BUILDING PERMIT REPORT

DATE: 19 MAY 99 ADDRESS: 936 BRIGHTON AVE. CBL: 260-B-001

REASON FOR PERMIT: Signage

SUBJECT: Request for Certificate of Occupancy
Rite Aid - 936 Brighton Avenue

SIGNAGE ELEVATION
NO SCALE

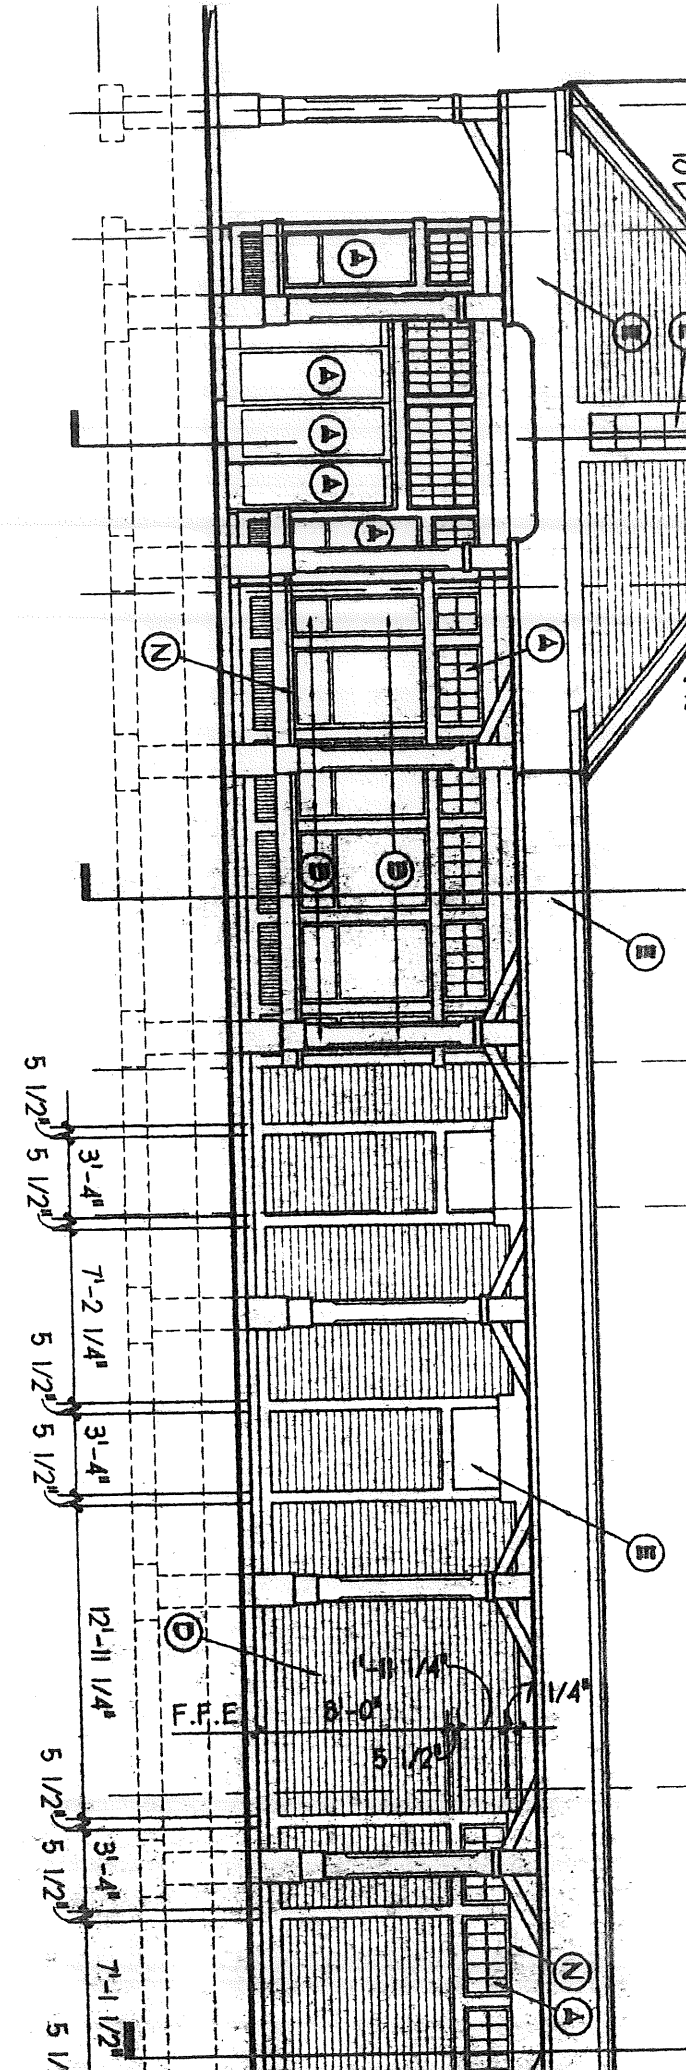
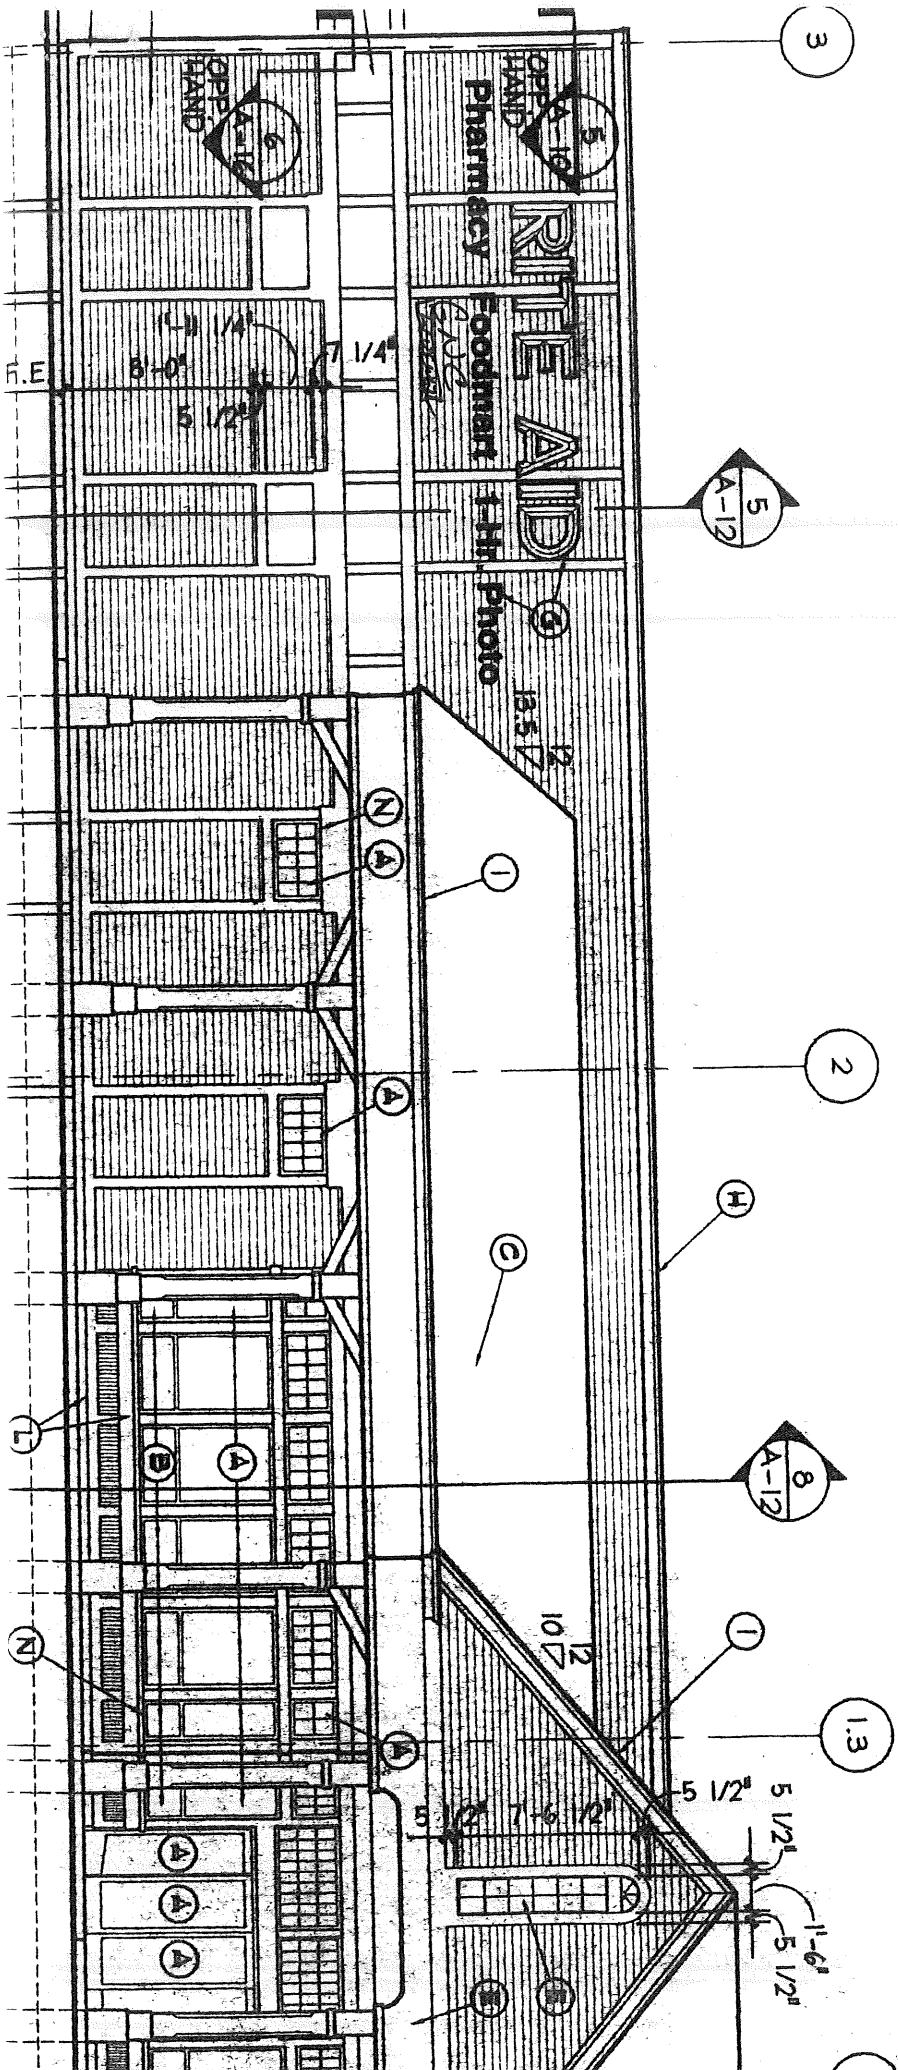
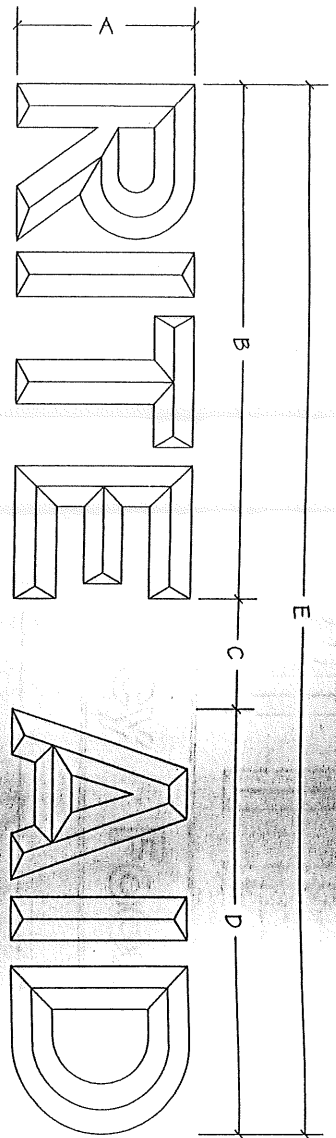
Shows 20.5' high pole sign
over size for pylon
16' high
Allowed
84" show
5 2#

5/18/99 Revised plans show 32' # and 16' high pylon sign
OK
SS
